**To:** Kristopher Byrd, Well Construction Section Manager  
**From:** Tommy Laird, Well Construction Program Coordinator  
**Subject:** Review of Water Right Application G-19207  
**Date:** October 19, 2023

# Groundwater Application Review Summary Form

Application # G- 19207

**SUBJECT: Scenic Waterway Interference Evaluation**

D1. Well #: 1 Logid: CLAC 68594

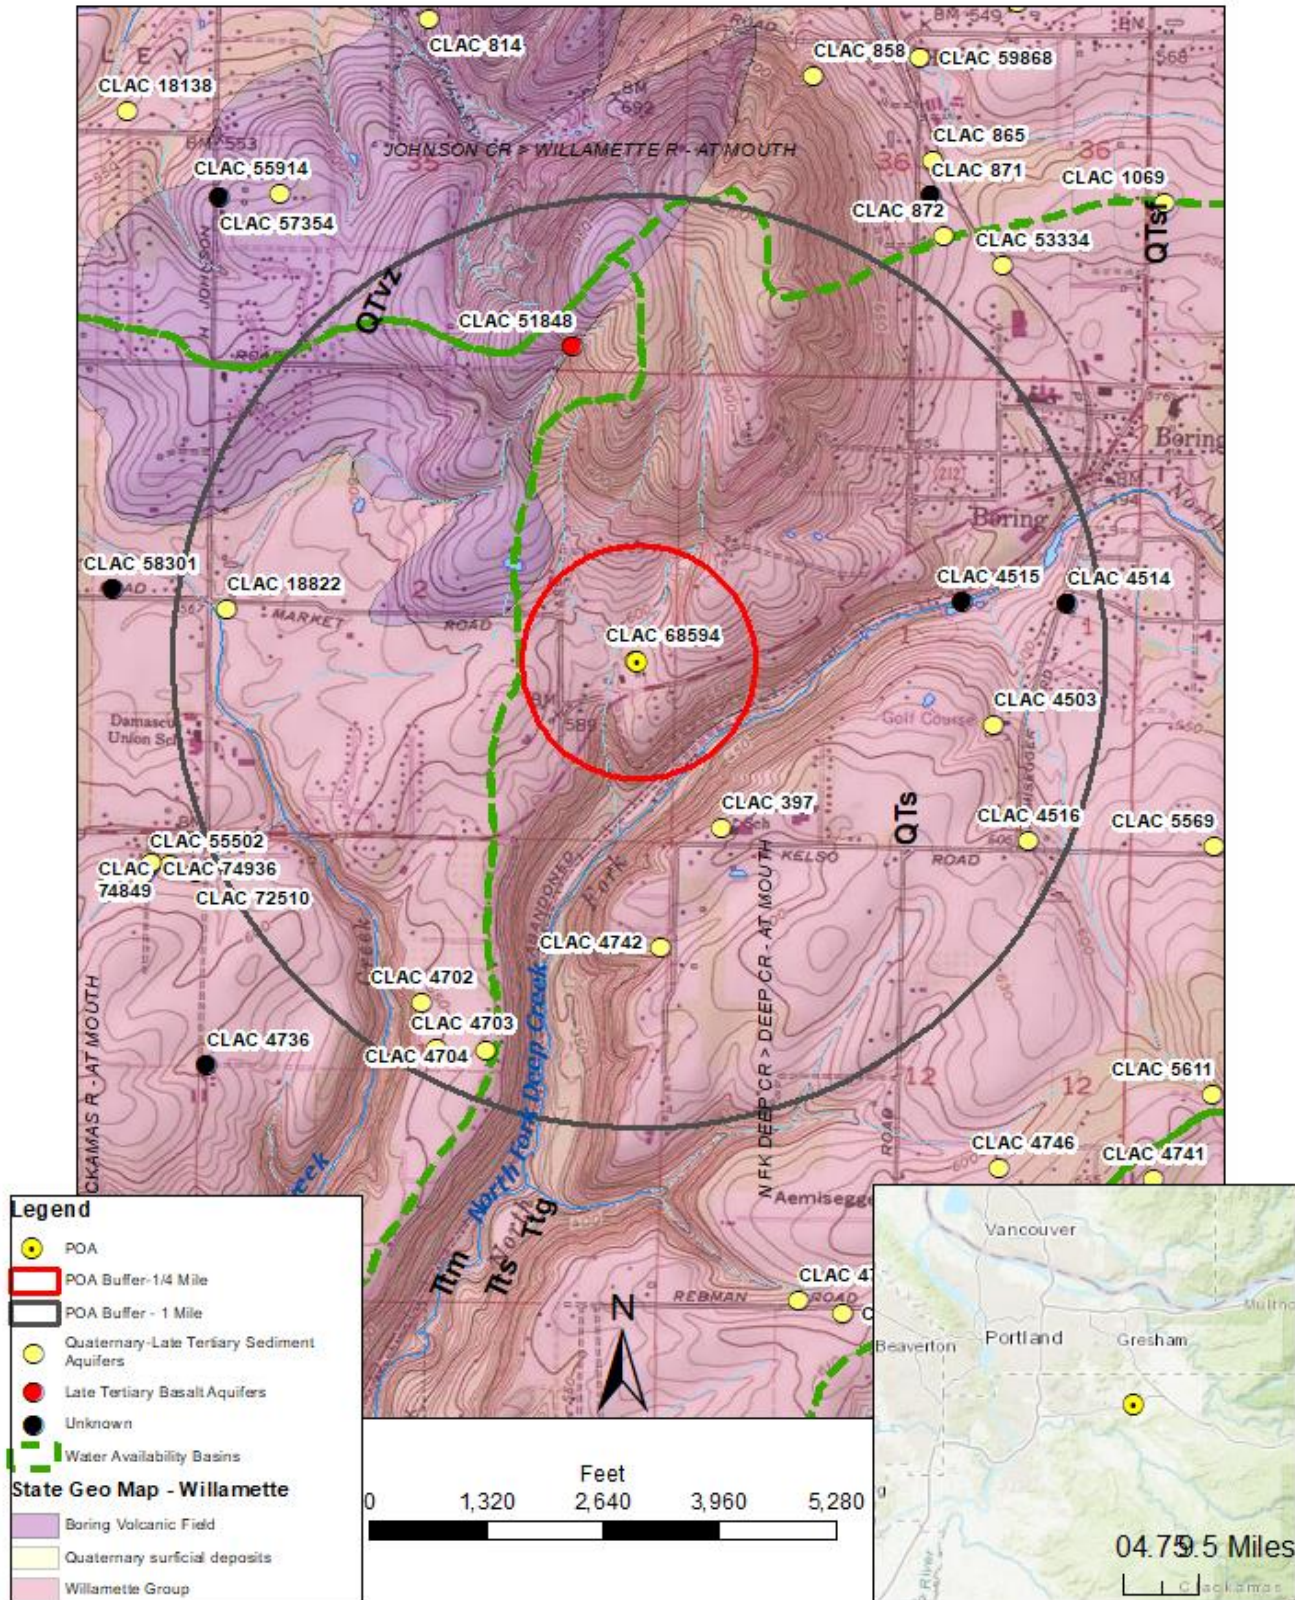
D2. **THE WELL does not appear to meet current well construction standards based upon:**

D3. **THE WELL construction deficiency or other comment is described as follows:** \_\_\_\_\_  
\_\_\_\_\_  
\_\_\_\_\_  
\_\_\_\_\_

D4.  **Route to the Well Construction and Compliance Section for a review of existing well construction.**
